Amendment No. 46
License No. DPR-35

ATTACHMENT TO LICENSE AMENDMENT NO. 46

SUPPORTING AMENDMENT NO. 46 TO FACILITY OPERATING LICENSE NO. DPR-35

PILGRIM NUCLEAR POWER STATION, UNIT 1

Figure 6.2.1

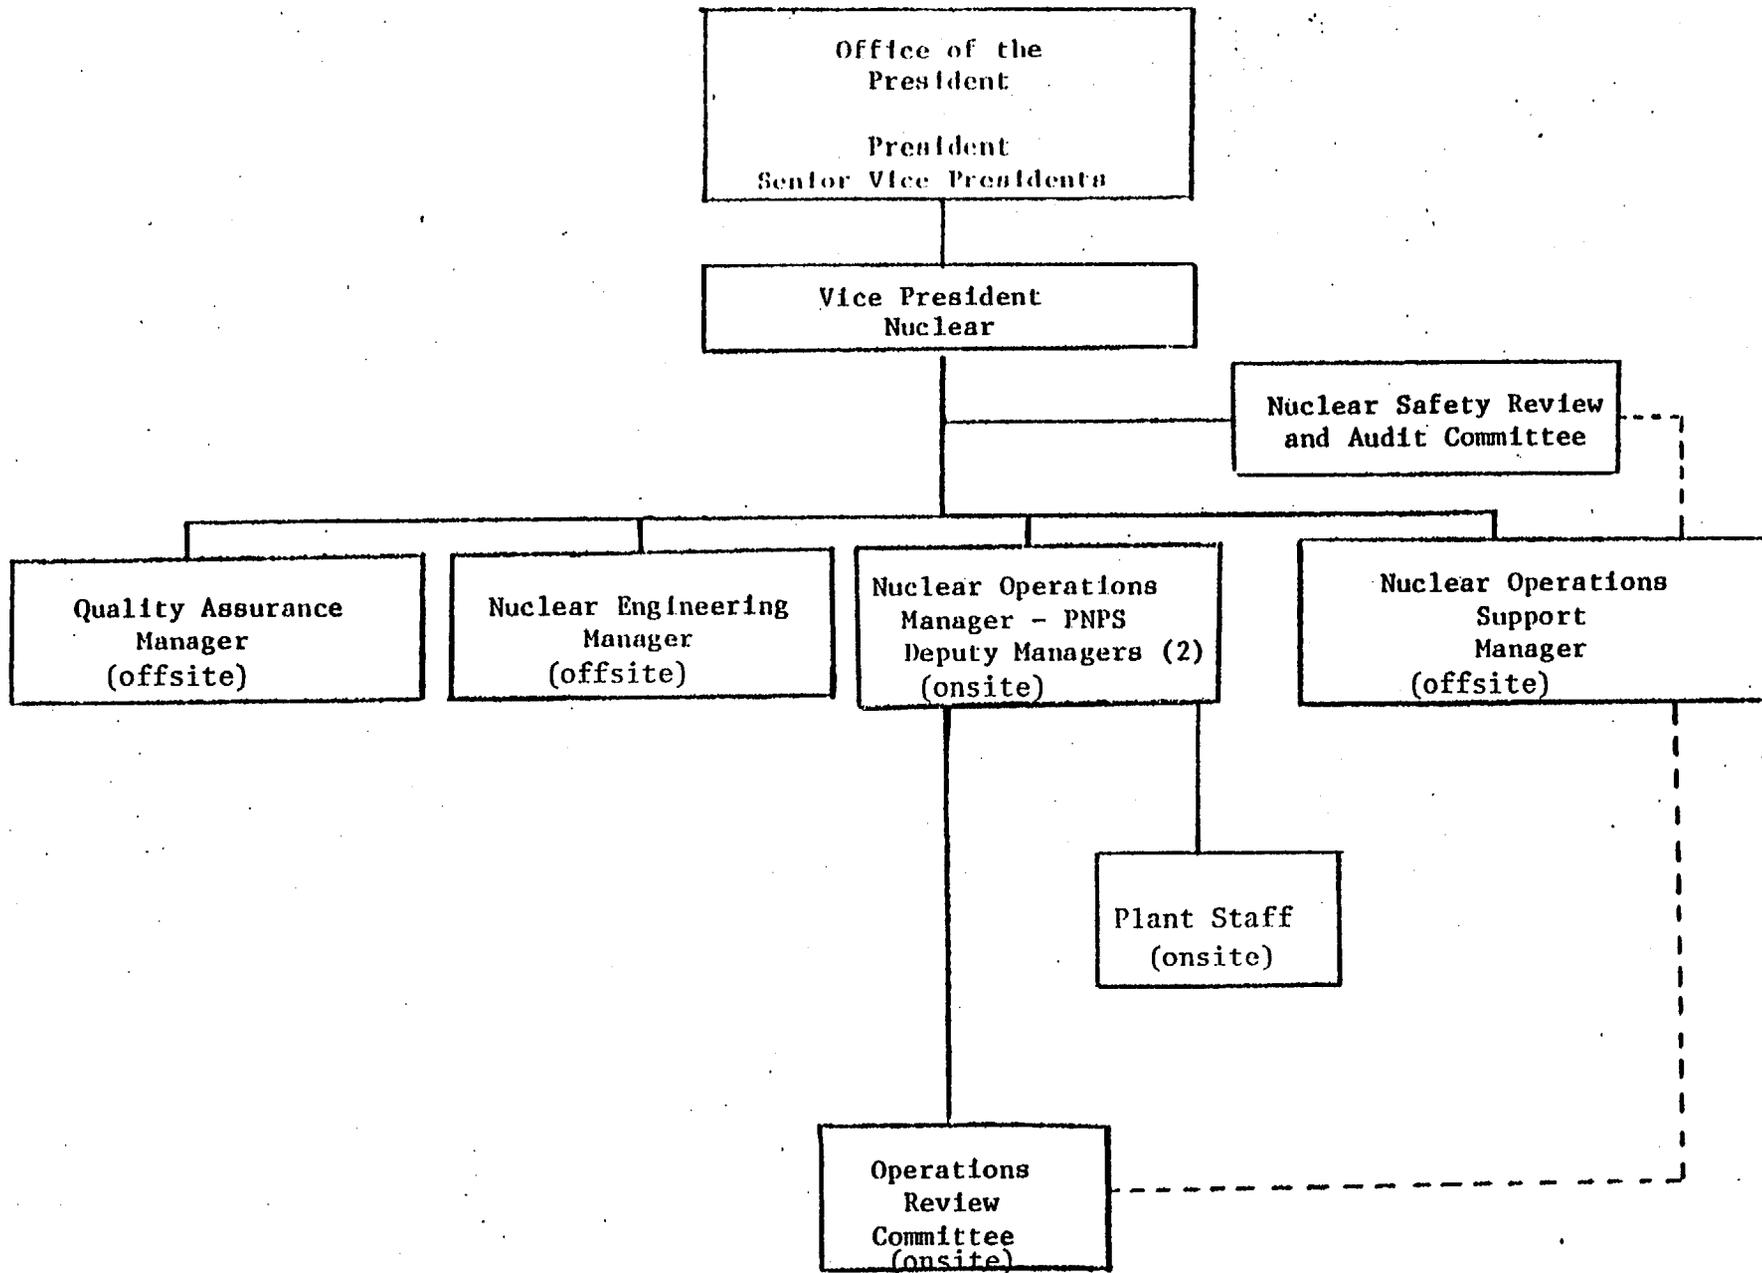
The title of the Pilgrim Station Manager has been changed to Nuclear Operations Manager and he now reports directly to the Vice President - Nuclear (Figure 6.2.1). Previously, the Pilgrim Station Manager (located on site) reported to the Nuclear Operations Manager (located off site) who, in turn, reported to the Vice President - Nuclear. Also reporting directly to the Vice President - Nuclear are the Manager Quality Assurance, Manager Nuclear Engineering, Manager Operations Support, and Nuclear Safety Review and Audit Committee, all located off site.

The new organization for operation of the Pilgrim 1 plant is shown on Figure 6.2.1. The licensee has agreed to change the figure to indicate which functions or groups are located on site or off site. A block showing the plant staff reporting directly to the Nuclear Operations Manager or the Deputy Managers will also be added to the organization chart shown on Figure 6.2.1.

PILGRIM 1 STATION ORGANIZATION
 FIGURE 6.2.2

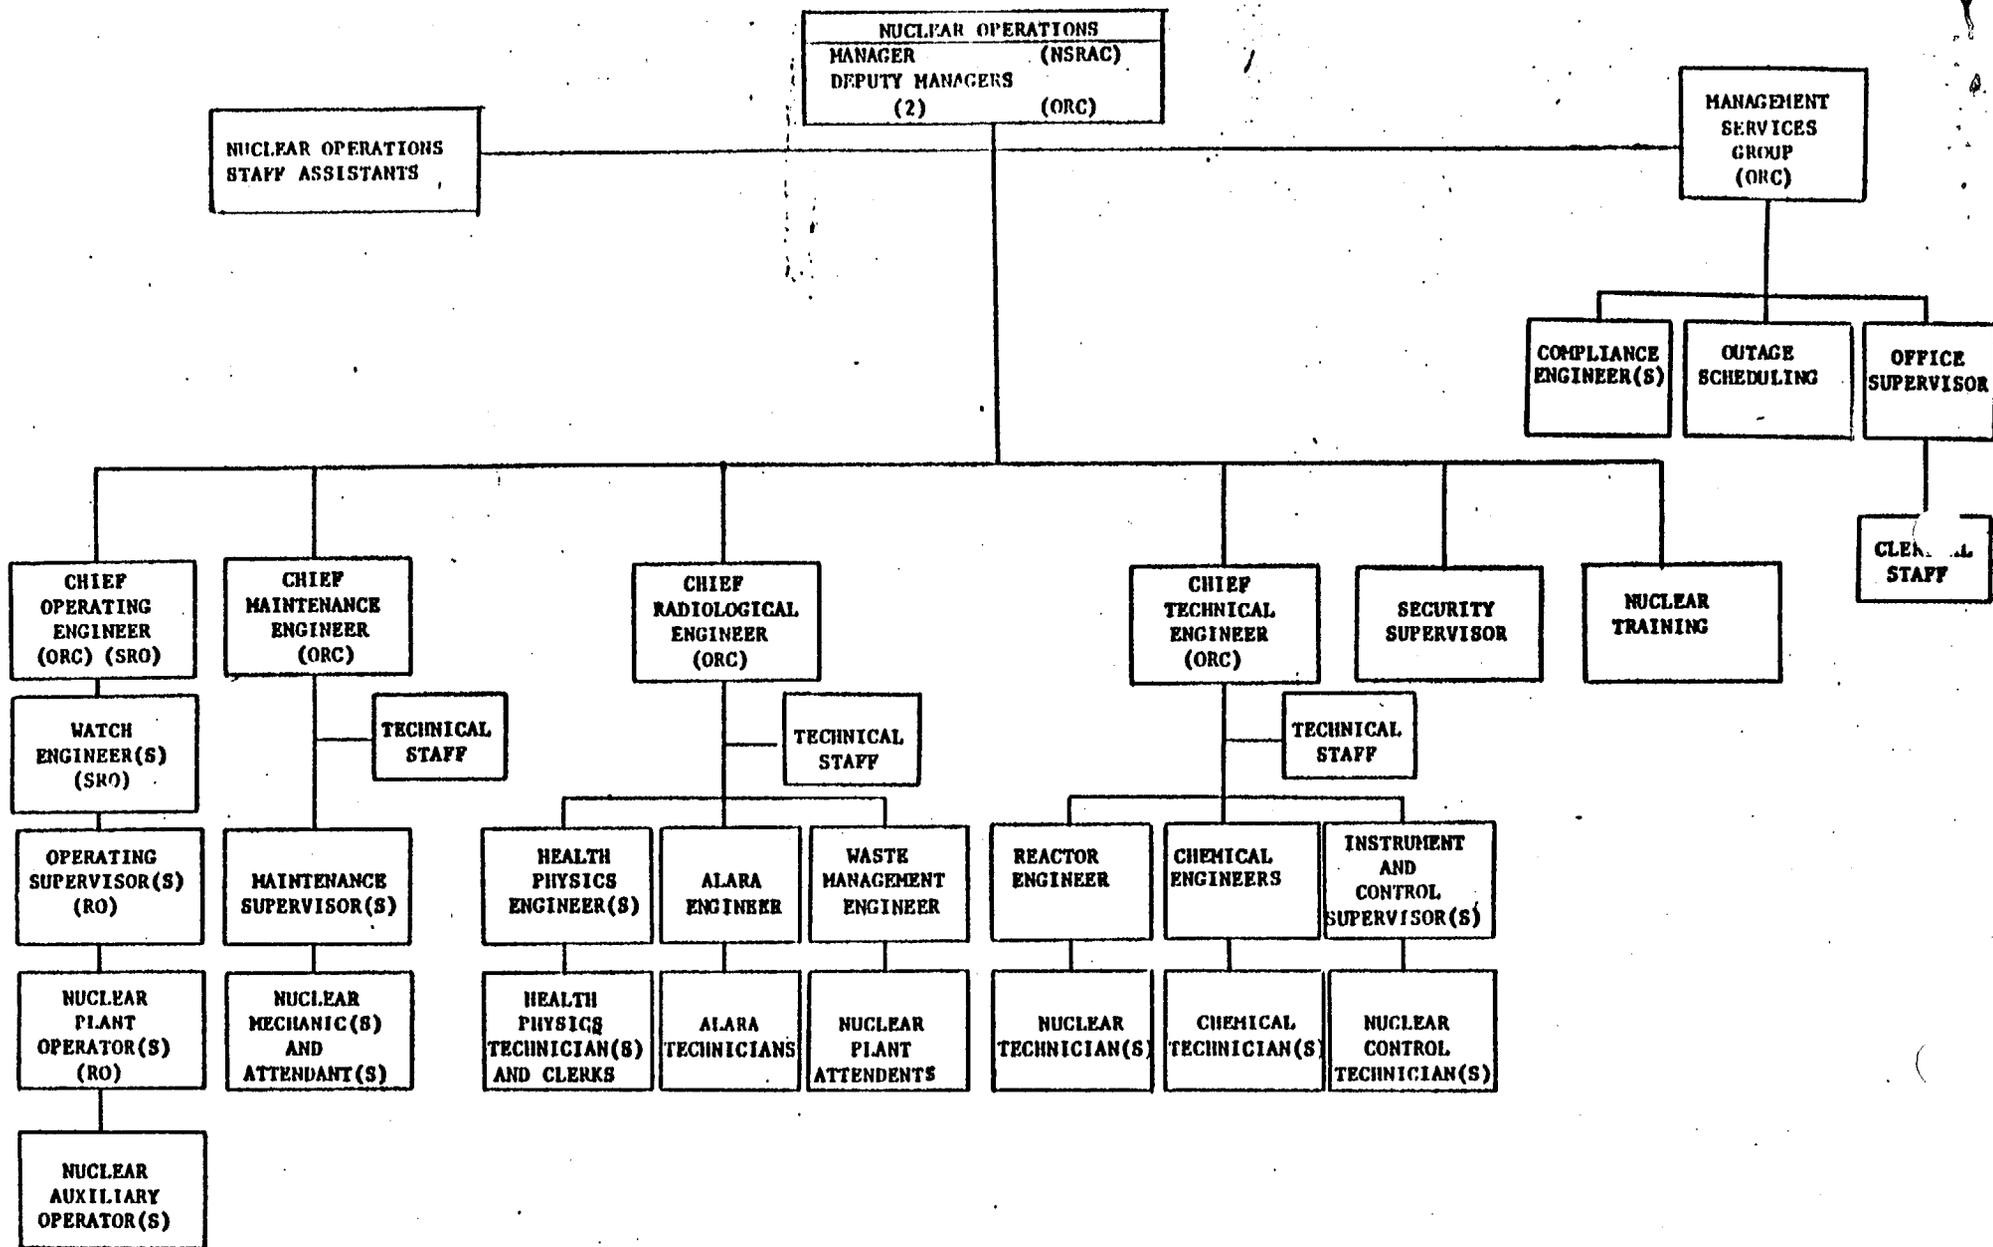
The new Pilgrim 1 station organization is shown on Figure 6.2.2. The Assistant Station Manager's title has been changed to Deputy Nuclear Operations Manager (two positions). The Chief Engineers of Operations, Maintenance, Radiology, and Technology who previously reported directly to the Station Manager, as well as those positions who reported to the Assistant Station Manager, now report directly to the Deputy Nuclear Operations Managers.

A new Nuclear Training Group has been established. The group reports directly to the Deputy Managers. This should enhance the status of training. The title of the Methods, Training and Compliance Group has also been changed to the Management Services group.

FIGURE 6.2.3

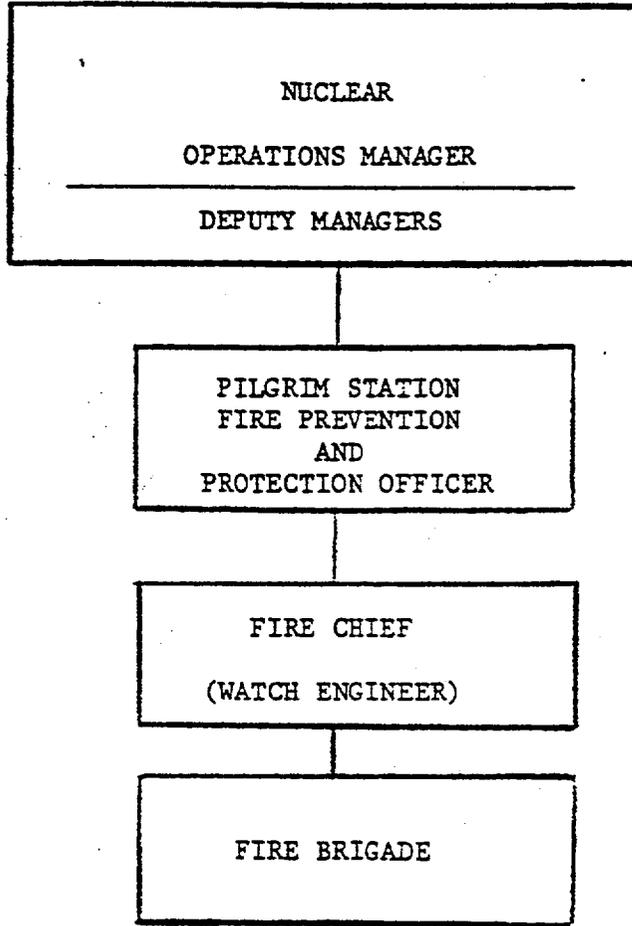
The position of Nuclear Operations Fire Prevention and Protection Officer has been deleted (Fig. 6.2.3). The composition of the Operations Review Committee (ORC) has also been changed. The Chairman of the ORC is now one of the Deputy Managers. Prior to the reorganization, the Station Manager was the Chairman. This is an acceptable change.
